Request for Class II Permissive Change

FCC ID: RI7LE910Q1WW

Please be notified that we, the undersigned, Telit Communications S.p.A. declare that the reasons for this Class II permissive change are as below:

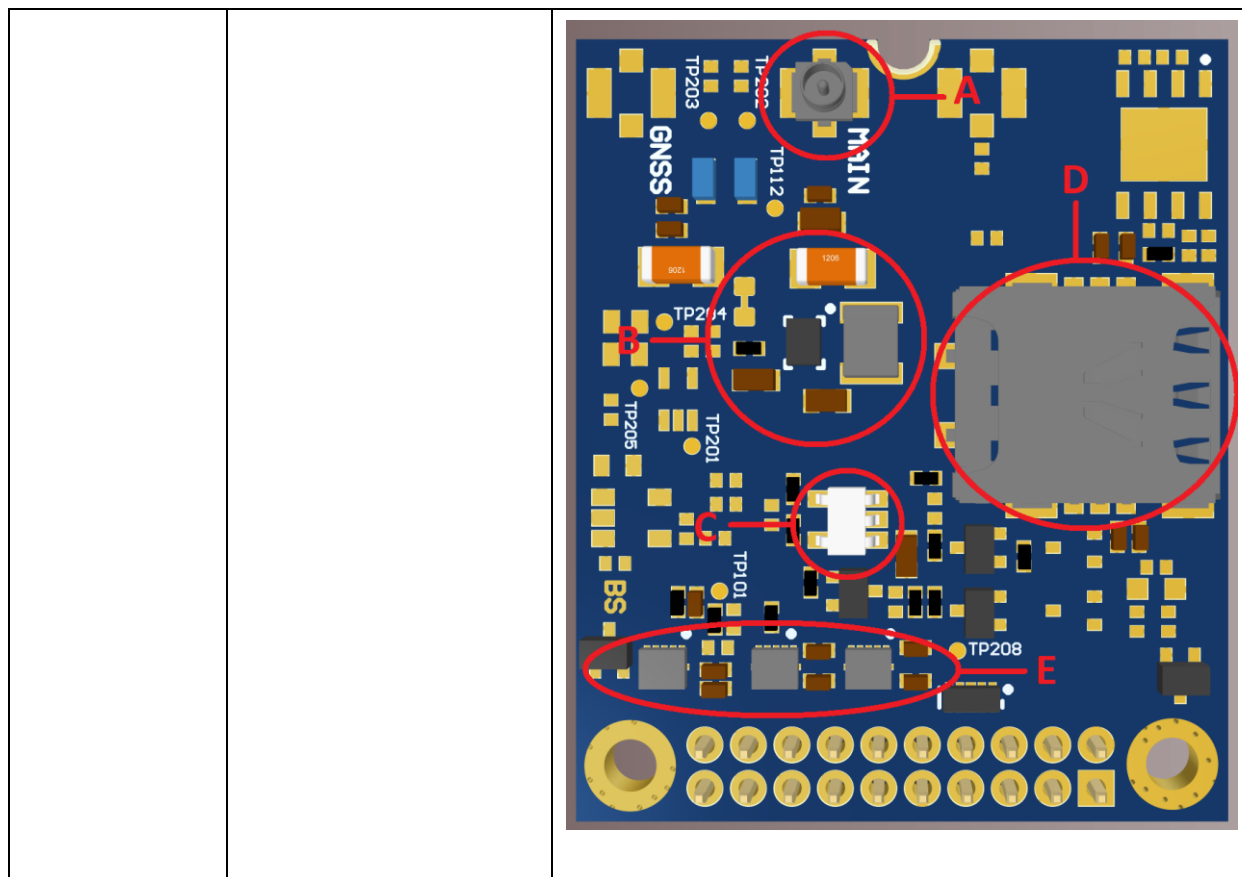
Model name	Radio module main features	Differences with LE910Q1-WW
LE910Q1-WW	Supports LTE FDD Cat 1 bis 3GPP Rel 14 compliant	---
CMB100B0-WW	Provided by LE910Q1-WW	HW: The LE910Q1-WW radio module is soldered on a PCB to provide custom connector for plug-in in final host devices, and the new equipment obtained is named CMB100B0-WW. Referring to the picture below, new PCB hosts: A) A U.FL connector for RF cable plug-in B) A buck-boost DCDC converter C) A LDO V.Reg D) Nano-SIM holder E) Communication signals level shifters
